Case File Number: PUD06010-R02

Location:	Brooklyn Basin (including 845 Embarcadero, 1- 9th Ave)
Accessor's Parcel Number:	018-0430-001-14, 018-0460-004-06, 08, and 11, and 018-0465-002-06, 12, 15, 27, 29, and 30
Proposal:	Public Hearing on the proposed Modifications to the Brooklyn Basin Marina Expansion Project. The Project Modifications include an increase of 600 residential units (for a Project site total of up to 3,700 units), allowance to relocate planned tower sites, an update to the parking ratios, and an expansion of the approved marina infrastructure and operation including increasing the number of slips by 158, and marina improvements to accommodate a water taxi/shuttle service.
Applicant:	Zarsion-OHP 1, LLC, Eric Harrison
Phone Number:	(510) 251-9280
Owner:	Zarsion-OHP 1, LLC
Case File Number:	PUD06010-R02
Planning Permits Required:	CEQA review, General Plan Amendment, Zoning Code Amendment, Revision to the Preliminary Development Plan for the PUD, Development Agreement Amendment, Conditional Use Permit

The purpose of this report is to provide information about the design components of the proposed Brooklyn Basin Project Modifications, and to seek any comments on the m

Planned and Proposed Tower Locations:

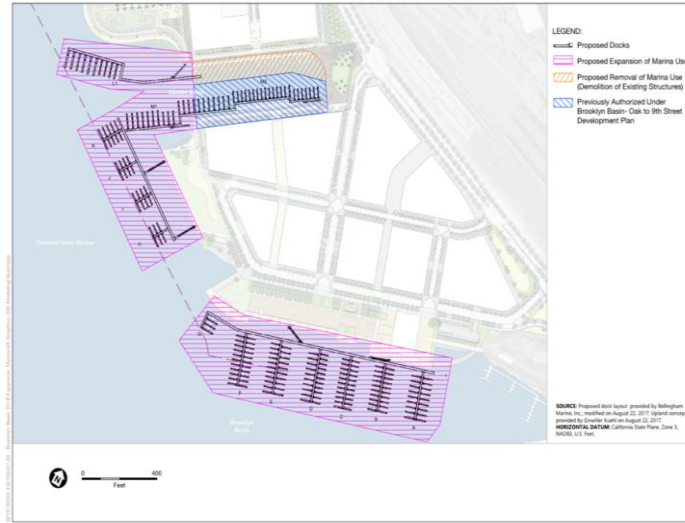
- **That the proposed design will create a building or set of buildings that are well related to the surrounding area in their setting, scale, bulk, height, materials, and textures:**
 - The proposed tower relocations would potentially intensify towers in the northwest portion of the project. Would the intensification of towers relate well to Gateway and South Parks, the Shadetree property, and the Fifth Avenue community? Would the intensification in this part of the site by one tower represent a substantial change from the planned development context?
 - *Staff believes that the relocation of a tower would not represent a change to the context surrounding Brooklyn Basin, and would not represent a*

- **That the proposed design will protect, preserve, or enhance desirable neighborhood characteristics;**
 - Would intensification of towers surrounding the Shadetree property and the Fifth Avenue community jeopardize the desirable neighborhood characteristics of those sites? The Shadetree property and Fifth Avenue community are both existing low-rise uses. Both sites are valued for fostering arts and culture within the Oakland community. The Shadetree property recently received permits for significant upgrades to further strengthen the legitimacy and permanency of creative uses at the site.
 - *Staff believes that the proposed intensification of towers adjacent to the two neighbors would not jeopardize the facilities or activities on those sites any more so than the planned project.*

- **That the proposed design will be sensitive to the topography and landscape.**
 - Not applicable: The proposed tower relocations would not increase the overall number of or mass of towers on the Brooklyn Basin site and would only shift tower locations on the existing site. Preservation of any established view corridors would be analyzed at the time of Final Development Permit submittal for individual development parcels.

Planned and Proposed Marina Expansion:

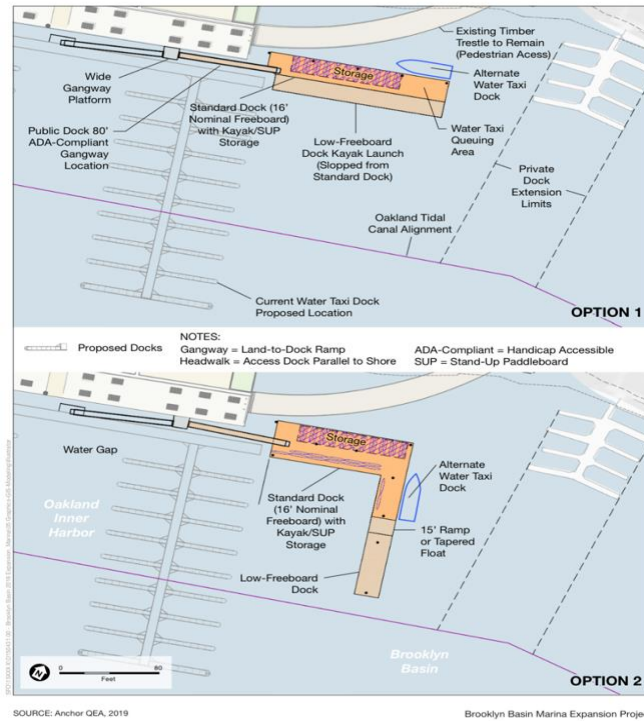
- *Do the expanded marina facilities relate well to South Park and Township Commons Park?*
 - *Do the marina and water taxi facilities fronting Township Commons Park, in particular, relate to the current design and use of Township Commons Park (which was not designed or constructed to provide access to a water taxi or marina facilities)?*

- *Would the water taxi facility, marina facilities and associated watercraft relate well to the setting of Township Commons Park and South Park?*
- **That the proposed design will be of a quality and character which harmonizes with, and serves to protect the value of, private and public investments in the area;**

- *Do the expanded marina facilities harmonize with and contribute to the value of the new public parks they front, South Park and Township Commons Park?*

- *Would access across City parks to the water taxi and marina facilities negatively affect the value of these City parks?*
- **That the proposed design conforms in all significant respects with the Oakland General Plan and with any applicable design review guidelines or criteria, district plan, or development control map which have been adopted by the Planning Commission or City Council.**

- *Do the expanded marina and water taxi facilities fronting the shoreline along Township Commons Park, in particular, comply with the Open Space, Conservation and Recreation Element of the General Plan (OSCAR)? The OSCAR does not include any specific policies prohibiting private marina facilities fronting City parks.*

- *Does access to private facilities (the water taxi and marina facilities) across City parks comply with the OSCAR? As noted above, the OSCAR does not have any specific policies prohibiting private marina facilities fronting City parks.*

Simulated Marina Expansion View:

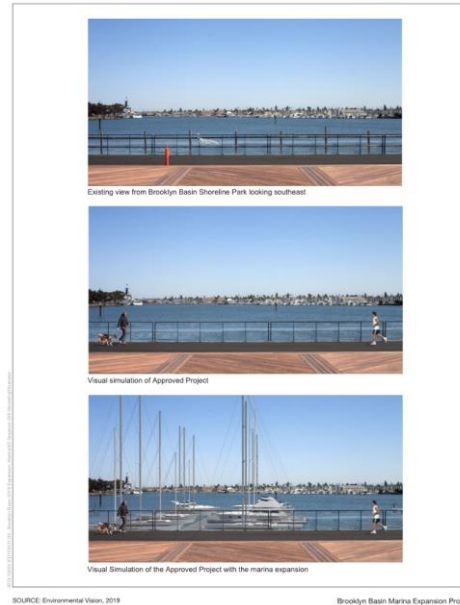
- How much parking is required to serve the marina and water taxi uses? Applicant should demonstrate demand and availability.
 - The applicant's renderings are inconsistent with the photo images shown in the same presentation. Boats and sailboat rigging will clutter and obscure the open views.

- Who was noticed for the PRAC meeting? Was the Measure DD Coalition notified?
 - The applicant renderings are unrealistic, relying on an imaginary muted color scheme for all improvements, and not showing slips at full capacity.
